HISTORIC AND DESIGN REVIEW COMMISSION

HDRC CASE NO: 2021-570
ADDRESS: 555 S ALAMO ST
LEGAL DESCRIPTION: NCB 901 BLK LOT 44, 45 & 46
ZONING: D, H, RIO-3
CITY COUNCIL DIST.: 1
DISTRICT: La Villita Historic District
LANDMARK: Individual Landmark
APPLICANT: James McKnight/Brown & Ortiz, PC
OWNER: Eric Stone/SAUTO HOTEL LLC
TYPE OF WORK: New construction
APPLICATION RECEIVED: October 28, 2021
60-DAY REVIEW: Not applicable due to City Council Emergency Orders
CASE MANAGER: Edward Hall

Historic and Design Review Commission
Design Review Committee Report

HDRC Case #: 2021-570

HKS PROJECT NUMBER
23383.000
DATE
10/15/21
ISSUE
50% CONSTRUCTION DOCUMENTS
SHEET TITLE
EXTERIOR ELEVATIONS-NORTH-EAST
SHEET NO.

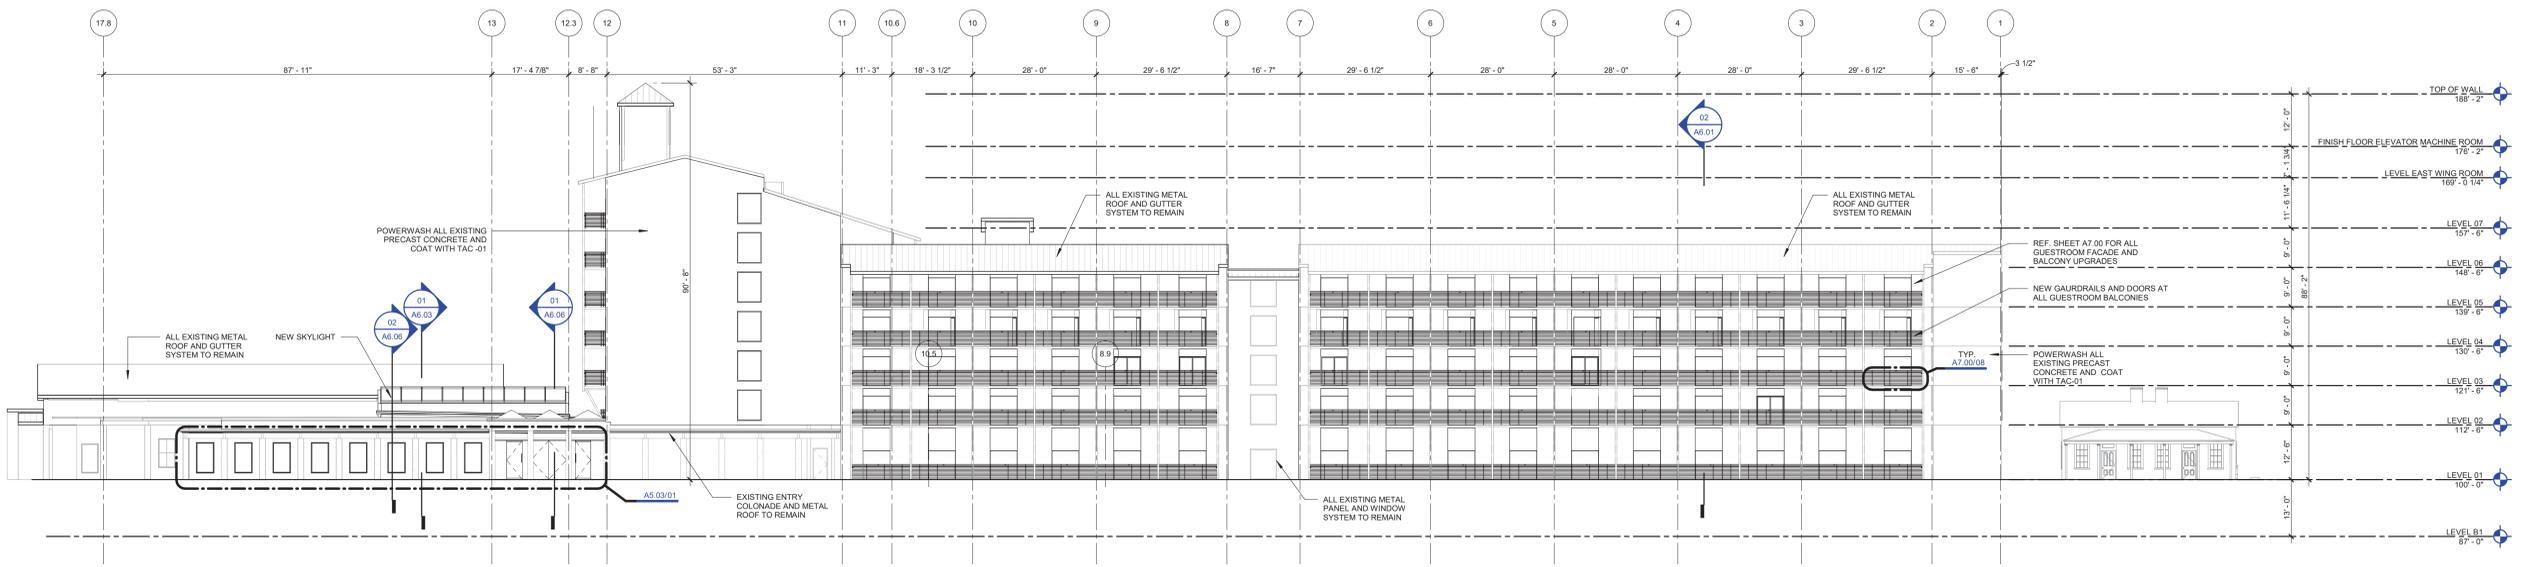
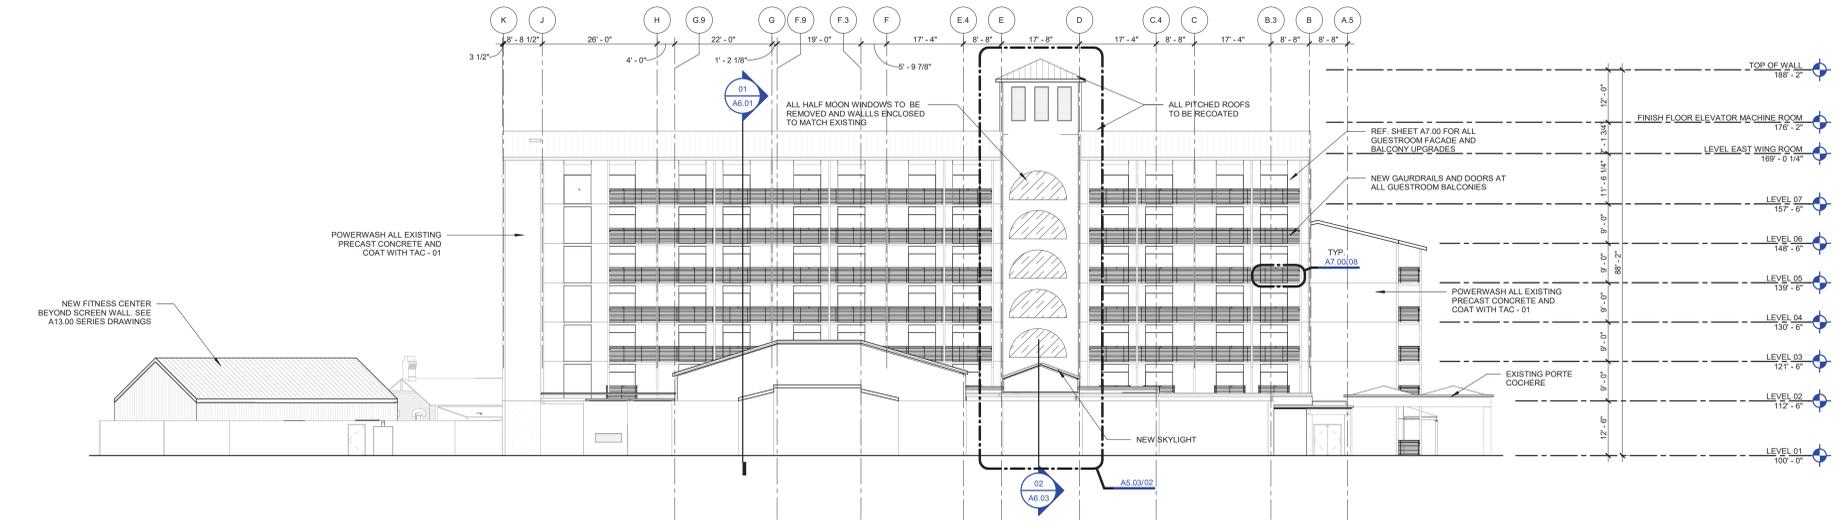
- i. **EVENT CENTER (Materials)** – The applicant has proposed materials that include a standing seam metal roof, composite wood panels feature a faux wood grain and horizontal profile and metal windows and doors. Staff finds that the proposed siding should feature a smooth finish instead of the proposed faux wood finish. Additionally, staff finds that the proposed standing seam metal roof should feature panels that are 18 to 21 inches wide, seams that are 1 to 2 inches in height and a crimped ridge seam. A low profile ridge cap may be submitted for review and approval by the Commission for new construction. Generally, staff finds the proposed zinc finish for the metal roof to be appropriate as it is comparable in color to the standard galvalume finish.

- j. **WINDOWS** – The applicant has proposed to install metal windows. Generally, staff finds the installation of metal windows to be appropriate; however, staff finds that all windows should be recessed at least two (2) inches within walls. All window frames, including frames of storefront systems should feature a dark finish.

- k. **ARCHITECTURAL DETAILS** – Generally, staff finds the architectural details of the proposed event center to be appropriate. Staff finds that the proposed composite siding should feature a smooth finish, as noted in finding i.

- i. That the proposed standing seam metal roof should feature panels that are 18 to 21 inches wide, seams that are 1 to 2 inches in height and a crimped ridge seam. A low profile ridge cap may be submitted for review and approval by the Commission for new construction.

- ii. That all composite siding should feature a smooth finish.
 - iii. That the proposed metal windows are inset two (2) inches within walls, feature dark colored frames and that all storefront systems feature dark colored frames.

A-2.1 PROPOSED NEW HIGH BUILDING SIGN
150 SF, HALO LIGHTING

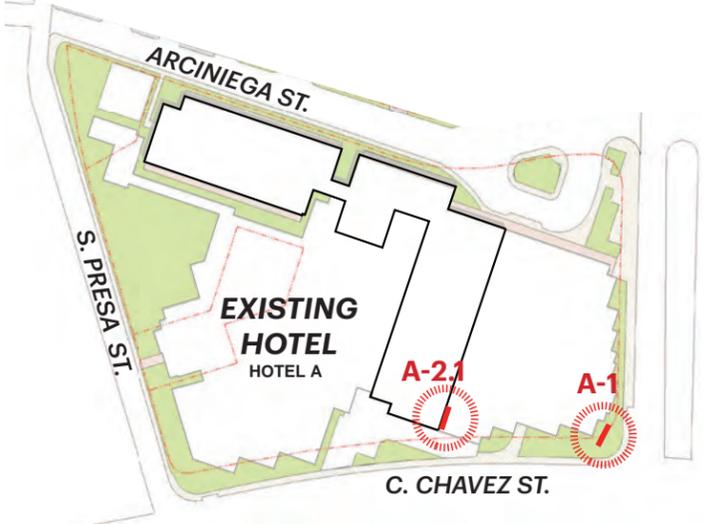
- s. **MONUMENT SIGNS** – The applicant has proposed to install three monument signs. One sign will be located at the intersection of S Alamo and Arciniega, one will be located at Arciniega and S Presa, and one will be located at within an existing landscaped area on Arciniega. The applicant has proposed for each sign to feature fifty (50) square feet, per side, to include a total of one hundred (100) square feet. The proposed signs will feature indirect illumination. While the size of the proposed signs exceeds the size recommended by the Guidelines for Signage, staff finds that given the size of the lot, the proposed size and number of signs are appropriate; however, staff finds that the proposed signage should not exceed six (6) feet in height, per the Guidelines.

- t. **BUILDING SIGNS** – The applicant has proposed to install two new building signs, one to be located on the east facing façade near Cesar E Chavez and one to be located on the south facing façade near S Alamo. The applicant has proposed for both signs to feature 150 square feet and halo lighting. Generally, staff finds the proposed signage to be appropriate.

- u. **BUILDING SIGN (Repair)** – The applicant has noted that the existing building sign on the north facing façade near S Alamo will be repaired. Staff finds this to be appropriate; however, the proposed signage repair should remain consistent with the Guidelines.

7. Staff recommends approval of item #7, signage, based on findings m through q with the following stipulations:
 - i. That the proposed monument signs do not exceed six (6) feet in height.

- ii. That all signage is externally illuminated, including existing signage that will be repaired.
